SERVICE BULLETIN SB1299

TERMS & CONDITIONS	: No claims will be accepted with reference to this Bulletin.
SUBJECT : Introduction of new generation DANA G171 drive	
DATE	: May 26th, 2016
BULLETIN TYPE	: Product Improvement
MANUAL SECTION	: 12.10 Drive axle
VEHICLE MODEL	: CX35, CX45, TX40, TX45, TDX25US
ADDRESSEES	: ABC Customer Care and Parts Source Owners and operators of coaches listed under 'Application'

SECTION THROUGH AXLE END

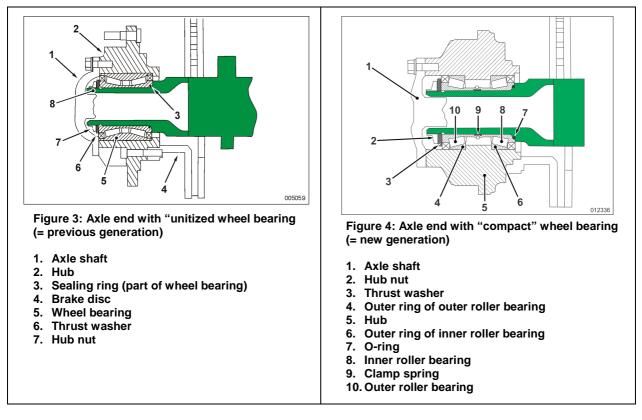
Dana Corporation have changed the wheel end bearing of the G171 drive axle from "unitized" to "compact" bearings. In line with this change associated components such as spindle, hub, hub nut & washer locking system and axle half shafts are also changed. The track of the new drive axle has maintained but the overall length is increased with 0.5 inch (12 mm). The purpose of this bulletin is to inform you about this change.

Figure 5: Axle end with "compact" wheel bearing (= new generation)

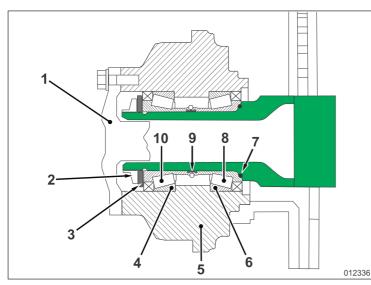
2. Procedure to remove wheel bearing- Figure 5

-
3	Remove the axle shaft.
4	CAUTION! Not fully undoing the staking of the hub nut can cause damage to the axle spindle thread when the hub nut is removed.
	With a pointed tool, fully undo the staking of the hub nut.
5	Remove the hub nut using the special hub nut wrench. Remove the thrust washer.
6	WARNING! The hub/brake disc assembly is heavy. Support it well before removing it.
	Pull the hub/brake disc assembly from the axle spindle.
7	Remove the brake disc from the hub.
8	Place the hub on a flat surface.
9	Remove the clamp spring located between the wheel bearings by using a flat blade screwdriver.
10	By using a hammer and a punch, drift the inner roller bearing together with the O-ring from the hub.
11	Turn the hub round and remove the other roller bearing in the same way.
·
